PRODUCT NOTICE

PN-1513

SUBJECT: Screen motor overload relay re-wire

DATE: December 18, 2015

Original Schematic page 5 showing the area of the wiring rework.

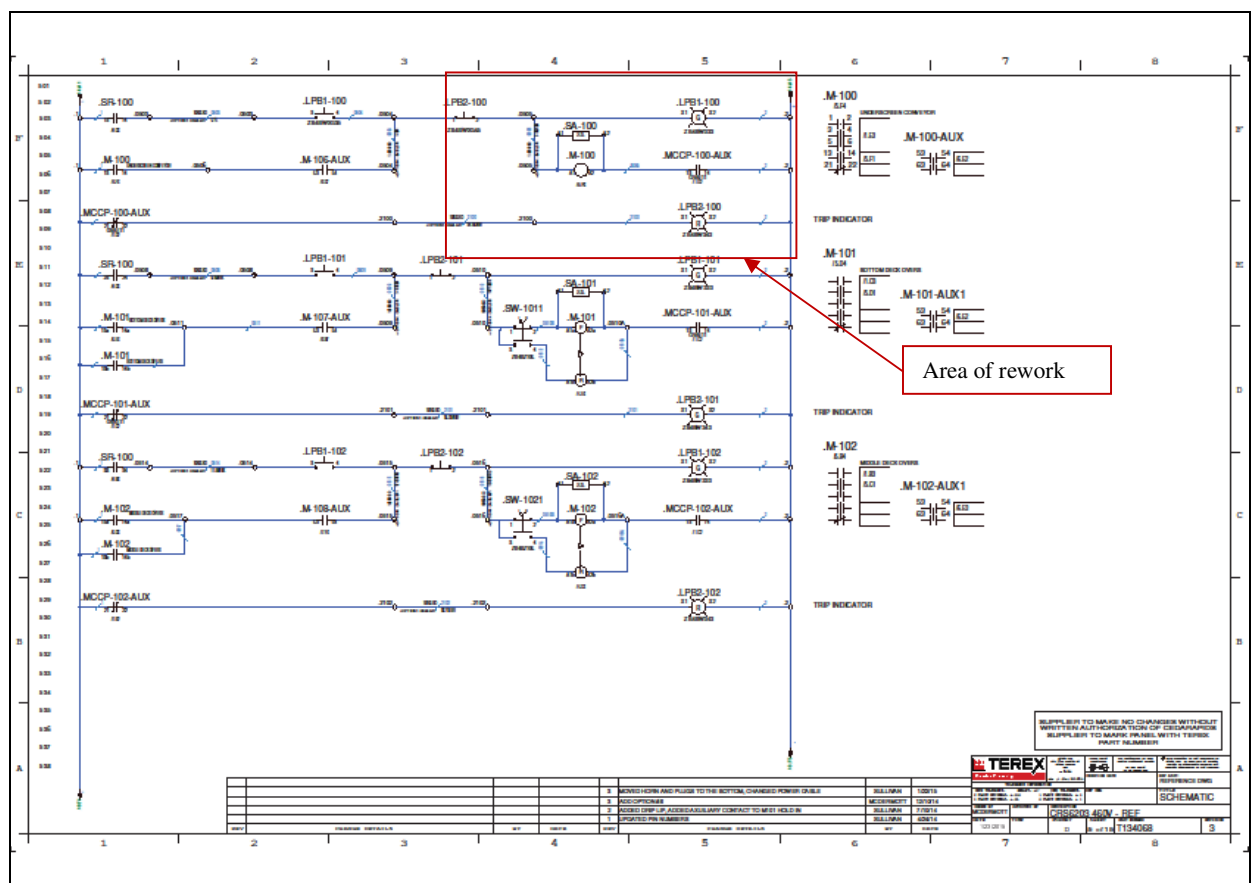
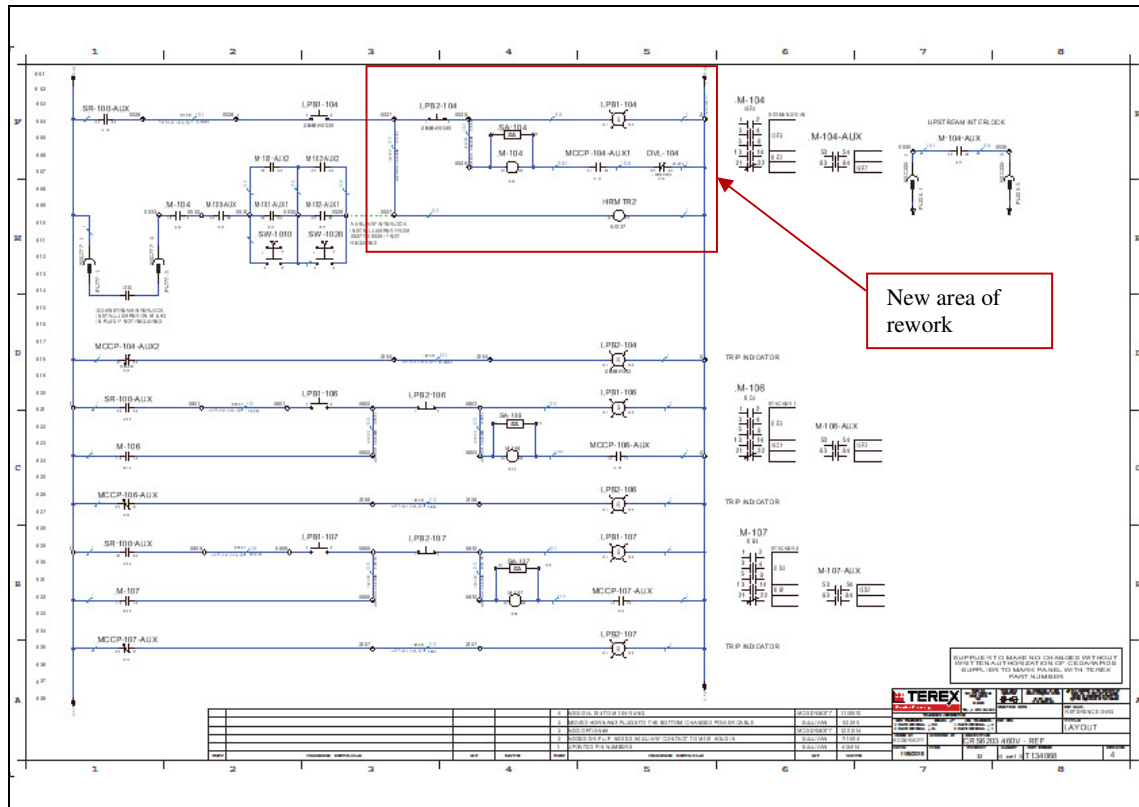
These instructions are to install one new wire and replace an existing wire in the electrical panel. The rework will isolate the Overload Relay from directly starting the screen motor if the Overload Relay reset button is manually pushed while there is power to the electrical panel. The plant electrical schematic is factory supplied and can be found inside the panel door.

New Schematic showing the area of the wiring rework including Overload Relay 104.

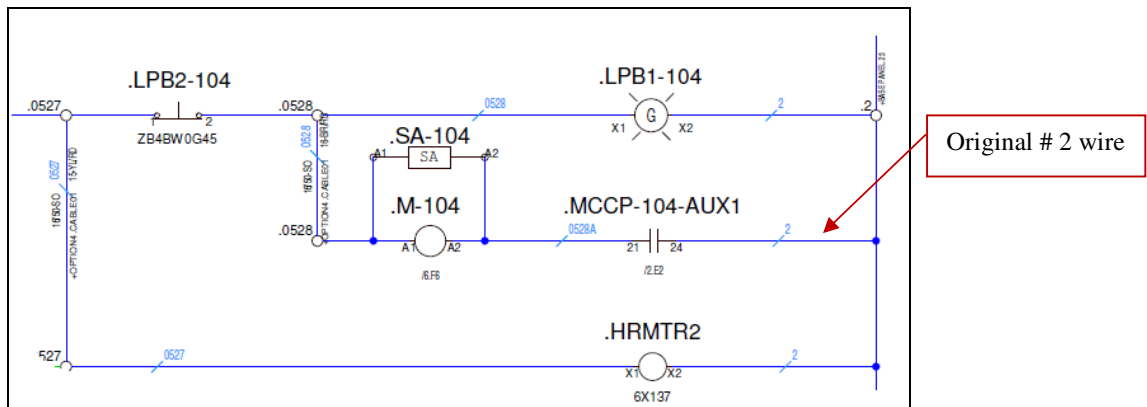
1. Remove the #2 wire from pin 24 on the MCCP104 Circuit Breaker Auxiliary Contact.

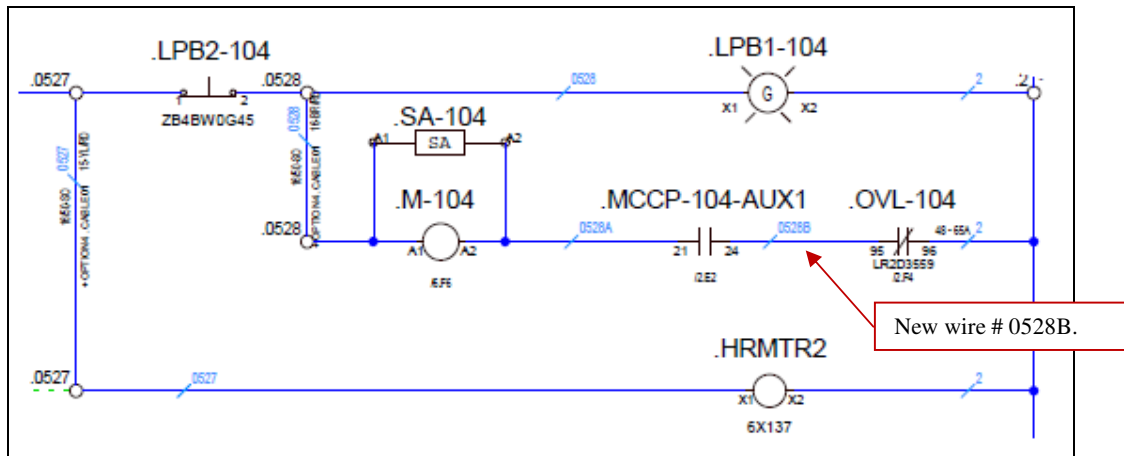
2. Install a new, red wire into pin 24 on this contact and make it long enough to reach pin 95 on Overload Relay 104. Label the new wire 0528B.

New # 2 wire from Pin 96 on the Overload Relay 104 to a # 2 terminal block.

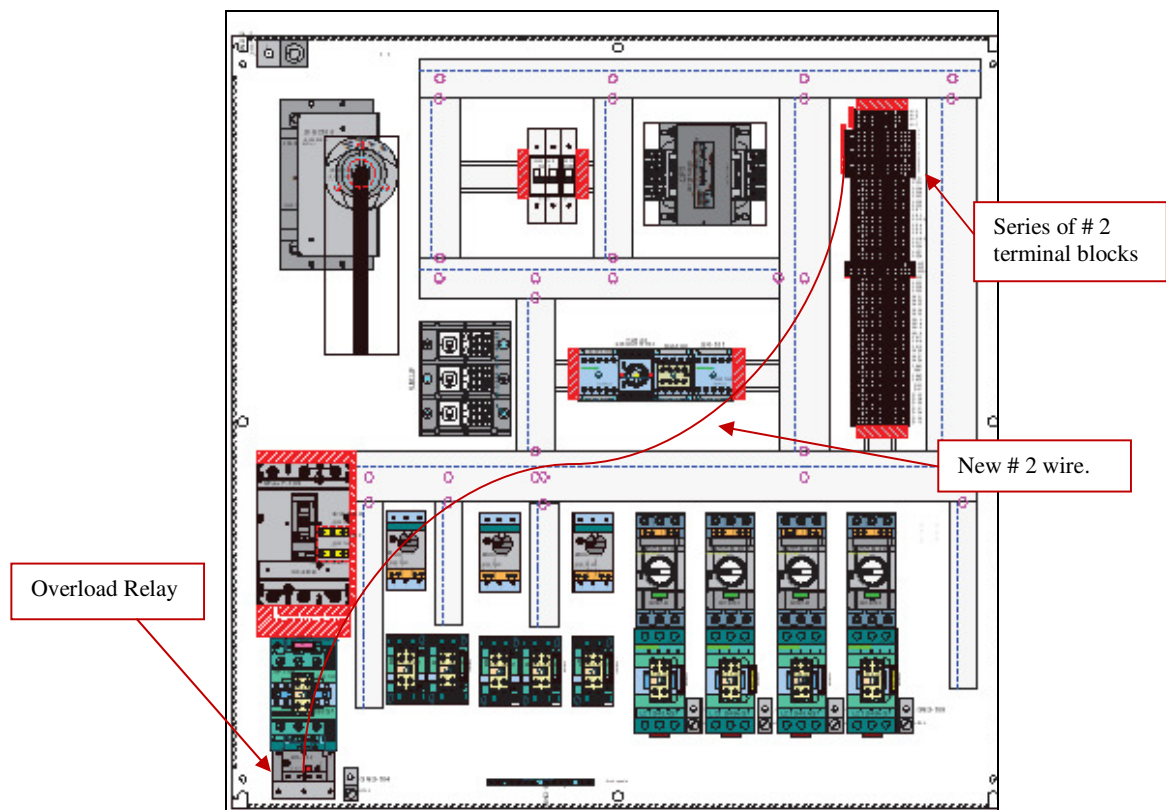
3. Make a new # 2 wire (longer) to reach from pin 96 on Overload Relay 104 to a # 2 terminal block in the main panel terminal blocks
